CHAPTER 2

COMMENTS AND RESPONSES TO COMMENTS ON THE DRAFT EIR

Subject: Comments on Draft Environmental Impact Report for the South Bay Aqueduct Improvement and Enlargement Project, Alameda County, California

Figure D-1
Mitigation Area and Buffer Zone
Altamont Landfill and Resource Recovery Facility
Original Alameda County Conditional Use Permit (C-5512)

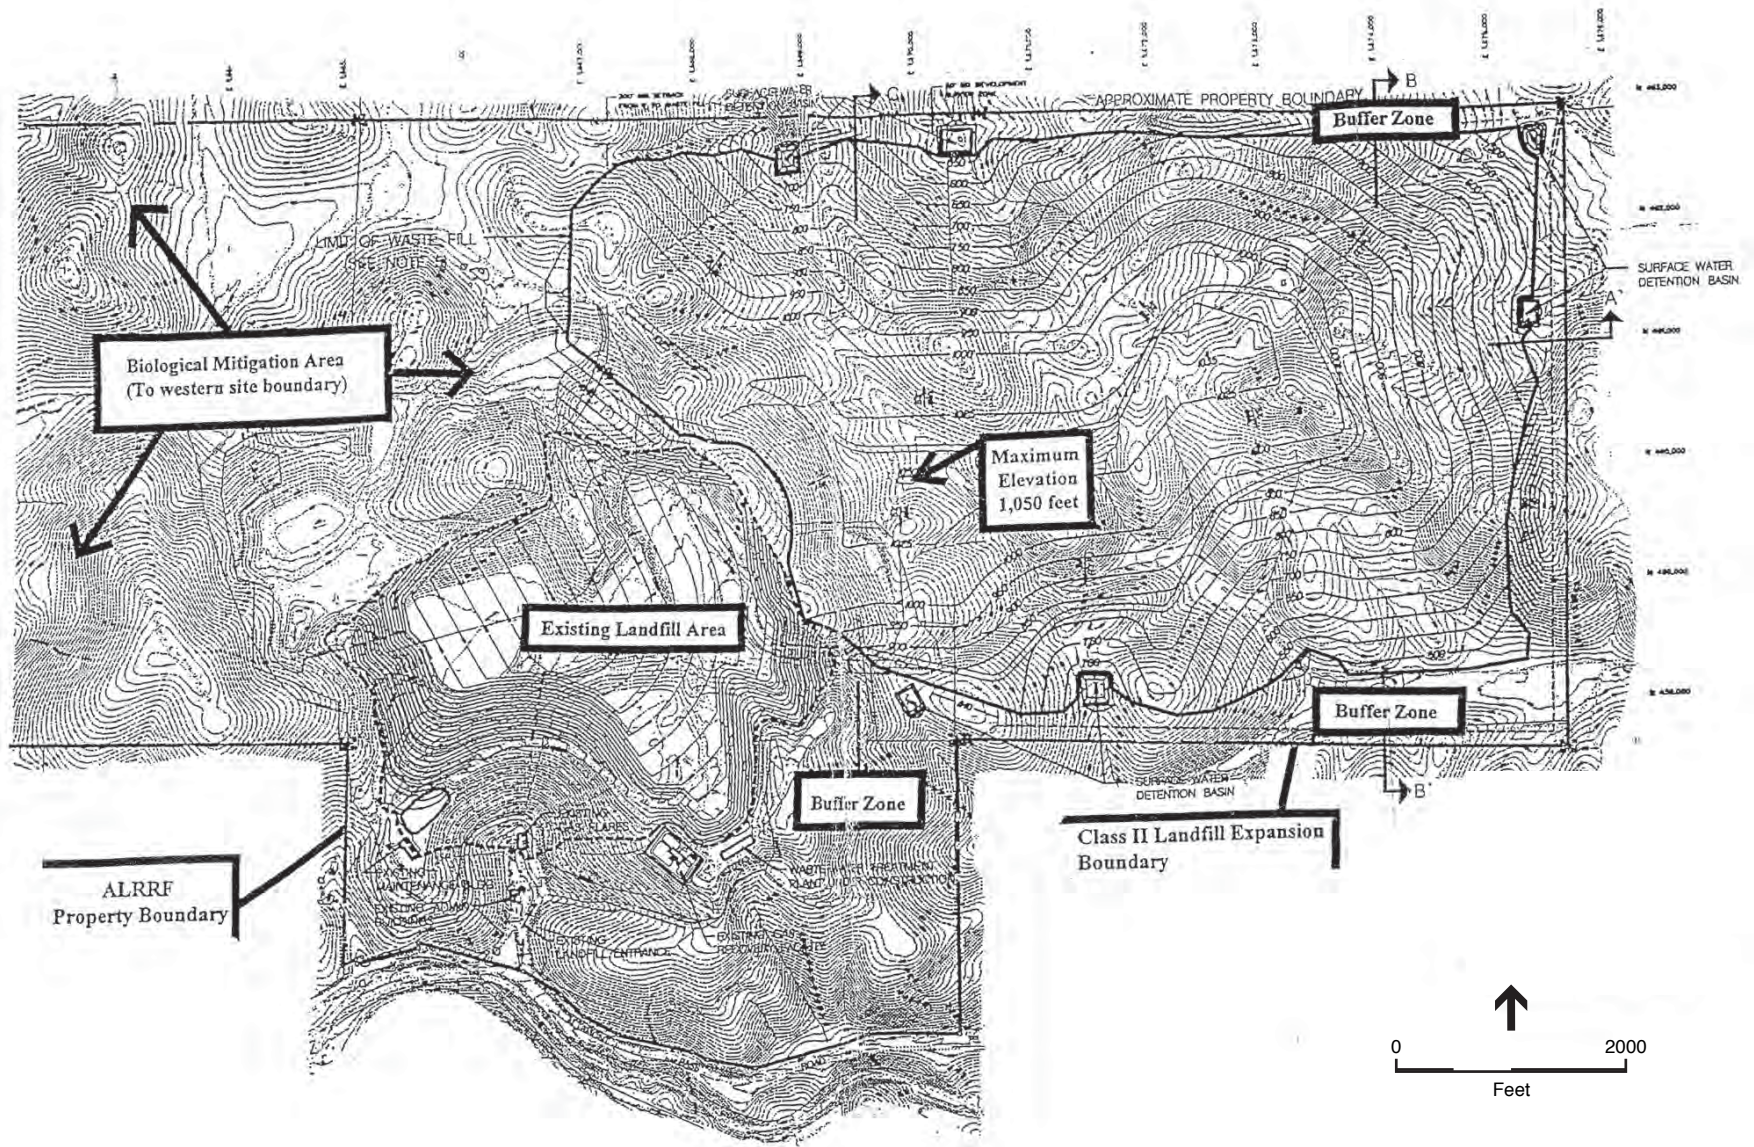
As defined in Conditions 16-27 of C-5512 adopted March 6, 2000 (attached), the mitigation and buffer areas are located, "... in Sections 15, 16, 17 and 21, substantially as depicted in Exhibit I." This exhibit appears in Volume 2, Appendices of Conditional Use Permit C-5512, the *Altamont Landfill and Resource Recovery Facility (ALRRF) - Class II Expansion EIR (SCH# 92083047)* in the January 17, 1995 LSA Associates, Inc., *ALRRF Biological Assessment, Figure 7, Mitigation Area*. This biological assessment report and exhibit were adopted as part of the Final EIR document and conditional use permit. As adopted and certified by the Alameda County Board of Supervisors, these documents have full legal standing under the California Environmental Quality Act (CEQA). Feasible mitigation measures that have been made conditions of approval are not subject to change by any party without additional CEQA review; the requirements of the condition must be either implemented, or the physical ability to implement the condition must be maintained until it is feasible to do so.

- D-3 Comment acknowledged. DEIR Section 3.4, Land Use, contains a discussion of the mitigation requirements imposed on Waste Management of Alameda County (WMAC) under Conditional Use Permit (CUP) C-5512 issued to WMAC by the Alameda County Board of Supervisors on March 6, 2000. This Conditional Use Permit approved a landfill expansion project that was substantially reduced from the one included in WMAC's original application, and includes the two separate mitigation requirements mentioned in this comment letter. Conditions 16-27 require WMAC to set aside 750 acres of land for mitigation of biological resource impacts "in Sections 15, 16, 17, and 21, substantially as depicted in Exhibit 1." Condition 7 requires that "Buffer zones shall be retained on site around the perimeter of the landfill footprint substantially as indicated in Exhibit 1." Alameda County has indicated that the referenced Exhibit 1 appears in Volume 2, Appendices of Conditional Use Permit C-5512, the Altamont Landfill and Resource Recovery Facility (ALRRF) – Class II Expansion EIR (SCH#92083047) (ESA, 1995; See **Figure D-1**), and is based upon the January 17, 1995 *LSA Associates, Inc. ALRRF Biological Assessment, Figure 7, Mitigation Area* (LSA Associates, 1995; See **Figure D-2**). Exhibit 1 delineates the perimeter of the landfill expansion as originally proposed by WMAC (reflecting a 750-acre expansion), rather than the perimeter of the 250-acre expansion as approved in the CUP.

As discussed on DEIR pp. 3.4-19 through 3.4-20, the four sections referenced in C-5512 Conditions 16-27 comprise approximately 2,560 acres of land. With the existing landfill (230 acres) and approved landfill expansion area (250 acres), approximately 2,000 acres of land would remain available within these four sections to meet this mitigation requirement. **Figure D-3** depicts the perimeter of the existing landfill and approved expansion, which is reduced from the proposed expansion depicted in Exhibit 1 (ESA, 2000). As stated on DEIR p. 3.4-19, construction of Dyer Reservoir as proposed would result in the temporary disturbance of 45 acres of open space area, and the permanent loss of 27 acres associated with the reservoir structure. The areas temporarily disturbed will be restored following construction, and the permanent loss of 27 acres is not anticipated to preclude or affect WMAC's ability to meet its mitigation obligation as established under C-5512. The perimeter of the approved landfill expansion is a substantial distance from both the western boundary of WMAC property and the proposed Dyer Reservoir site, and implementation of Dyer Reservoir would not affect the maintenance of a buffer area between the active landfill operations and WMAC property boundaries.

Figure 3.4-2a

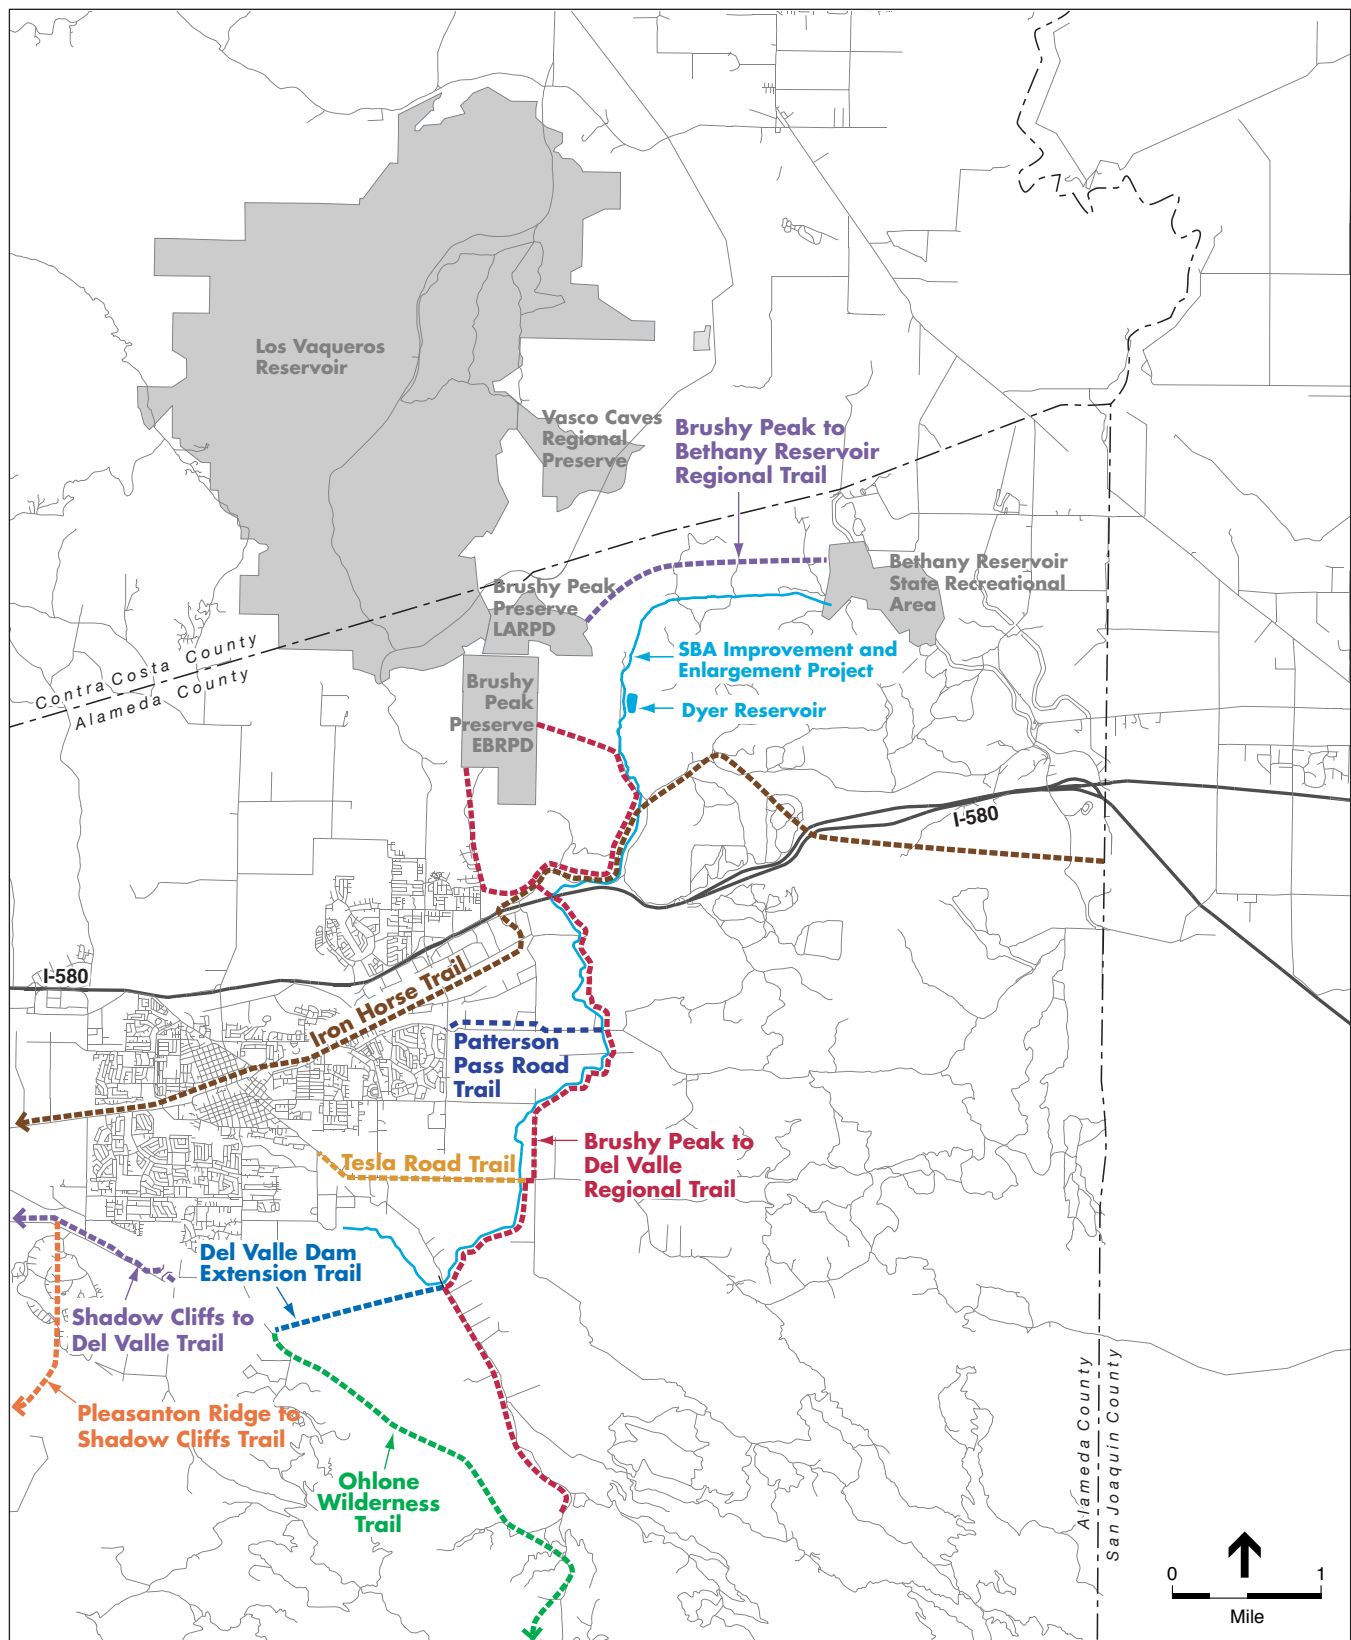
- Include Map of proposed or “planned” recreational facilities in vicinity consistent with area Master Plans (Similar to Figure 3.4-2).

- G-12 Comment acknowledged. Table 3.4-3 on p. 3.4-10 of the DEIR, and as revised per Response G-11, identifies proposed recreational facilities within proximity of the SBA project corridor. In response to this comment, **Figure 3.4-2a** has been incorporated into the EIR to show proposed recreational facilities within the vicinity of the SBA project corridor.

Figure K-1
Wind Turbine to be Removed
Along Stage 3 Brushy Creek Pipeline

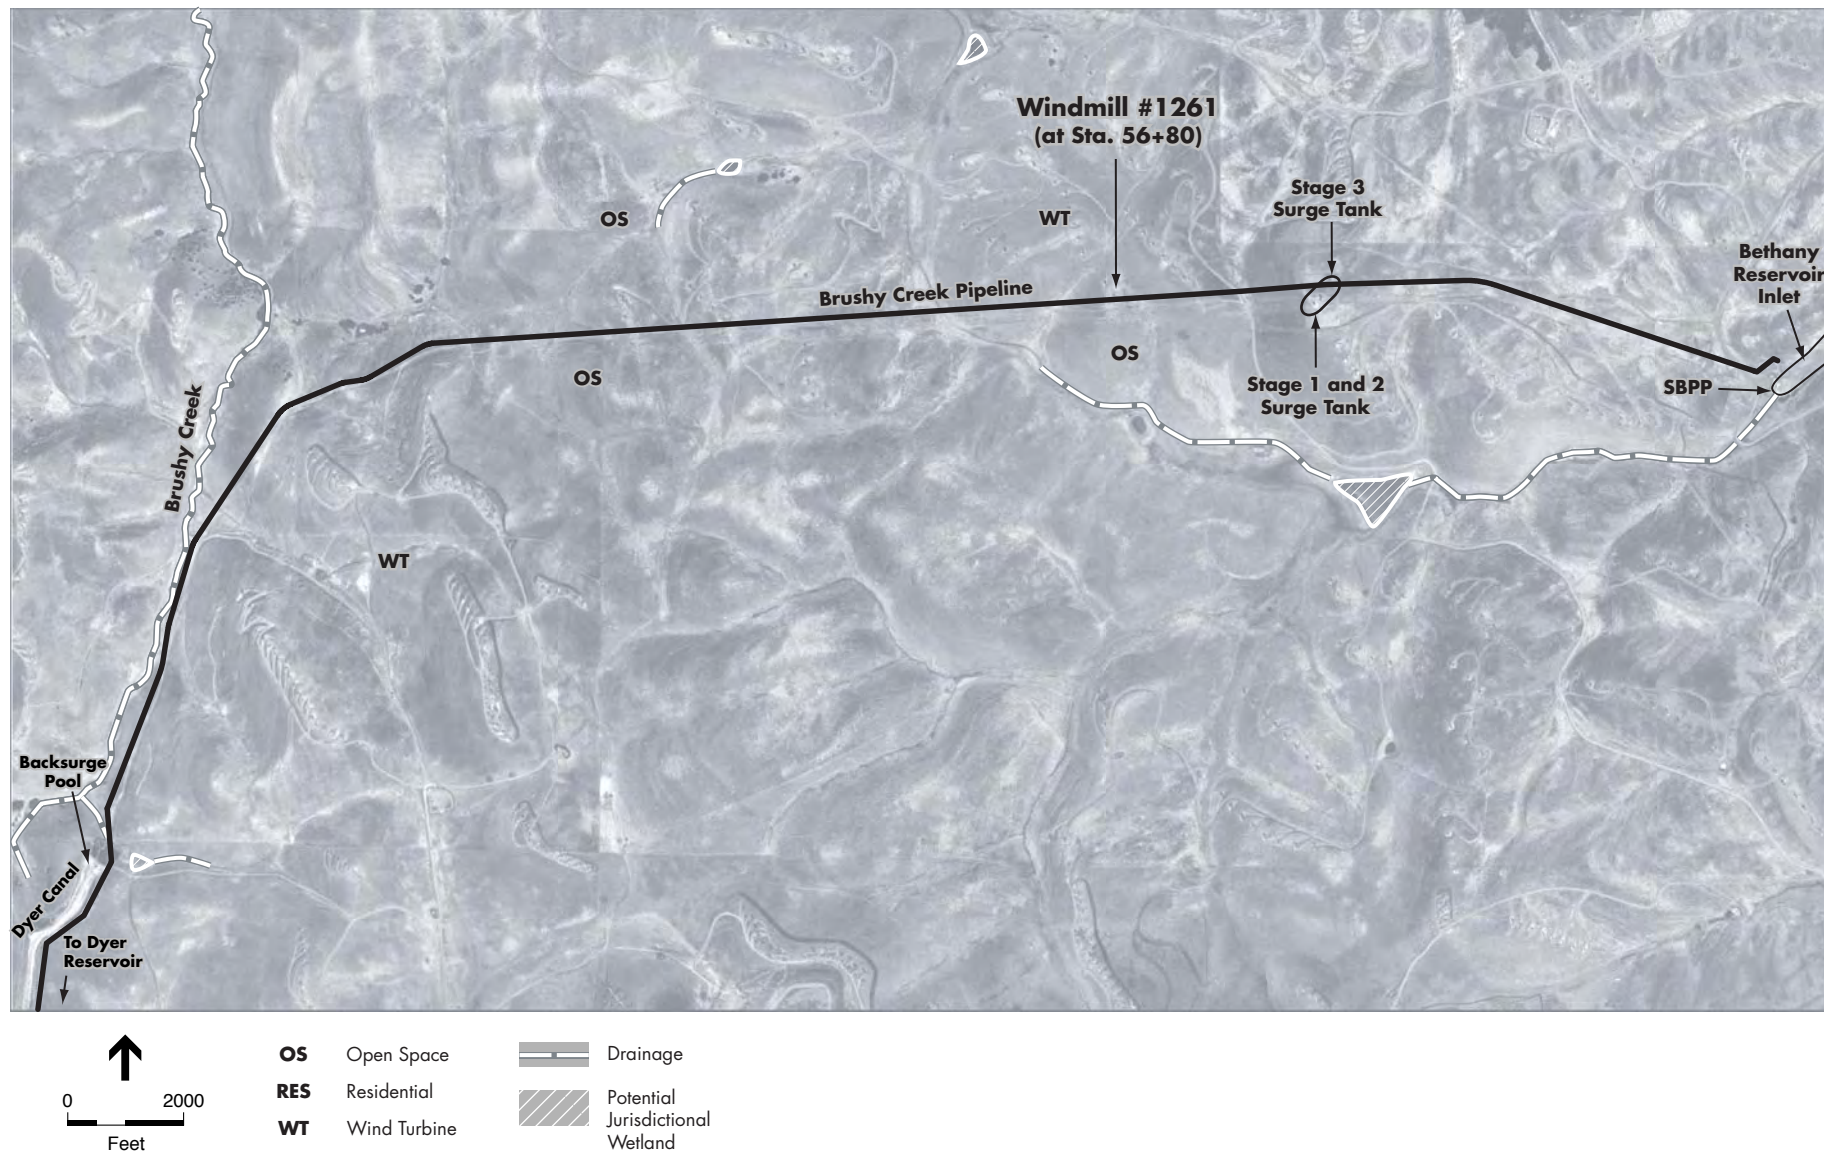
We are also considered about the possible encroachment on, and impacts to, our existing wind turbines in R3E, T2S, Section 3 from the 3- and 4-acre spoil areas shown in Figure 2-3. These spoil areas and the potential boundary of the construction zone appears to conflict with the locations of several of our wind turbines and access roads in the southeast corner of Section 3.

- K-2 Comment acknowledged. DWR will be removing one wind turbine (Windmill #1261, near Station 56+80) from operation during construction of the Stage 3 Brushy Creek Pipeline (see **Figure K-1**).
- K-3 Comment acknowledged. DWR will take appropriate measures to avoid accidental utility disruptions and will coordinate temporary disruptions with utility companies. Compensation for any accidental or planned temporary losses of service will be negotiated with utility companies. DWR has commenced discussions and negotiations with utility companies regarding monetary compensation for disruptions.
- K-4 Comment acknowledged. The Proposed Project will only displace one wind turbine, which is the same wind turbine that will be permanently removed. In response to this comment, the second paragraph on DEIR p.3.4-19 has been revised as follows:
